United States Patent and Trademark Office

APPLICATION NO.	FILING DATE	FIRST NAMED INVENTOR	ATTORNEY DOCKET NO.	CONFIRMATION NO.
10/738,549	12/17/2003	Reza M. Golzarian	109263-133806	8329
25943	7590 04/05/2005	EXAMINER		
•	WILLIAMSON & WYA	NGUYEN, GEORGE BINH MINH		
PACWEST CENTER, SUITES 1600-1900 1211 SW FIFTH AVENUE PORTLAND, OR 97204			ART UNIT	PAPER NUMBER
			3723

フリ			
		Application No.	Applicant(s)				
Office Action Summary		10/738,549 GOLZARIAN ET AL.		L.			
		Examiner	Art Unit				
		George Nguyen	3723				
Period fe	The MAILING DATE of this communication app or Reply	pears on the cover sheet wi	th the correspondence ad	dress			
THE - External control	MORTENED STATUTORY PERIOD FOR REPL' MAILING DATE OF THIS COMMUNICATION. ensions of time may be available under the provisions of 37 CFR 1.1 r SIX (6) MONTHS from the mailing date of this communication. e period for reply specified above is less than thirty (30) days, a reply of period for reply is specified above, the maximum statutory period of the provision of the provisions of the provisio	36(a). In no event, however, may a re y within the statutory minimum of thirty will apply and will expire SIX (6) MON' , cause the appli

FIG. 12

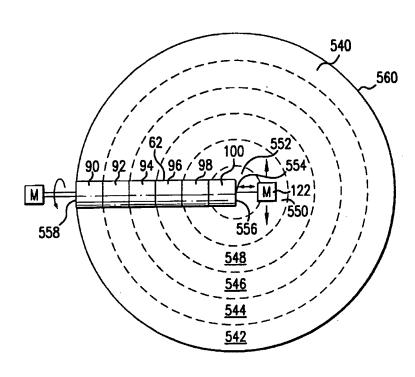
With reference to FIG. 12, col. 7, line 27 to col. 8, line 29, Chopra discloses the claimed invention including:

- a. control arm (not referenced number).
- b. at least one cylindrical conditioning piece 90.
- c. a rotatable polishing pad 560.
- d. a pivot point M in which control arm is coupled to.
- e. motor M to rotate the control arm.
- f. translational drive means 122 to move the conditioning tool 62 to and from radially with respect to the pad center 554.

Please note that in col. 8, lines 4-29, Chopra discloses the limitations of claims 16 and 18.
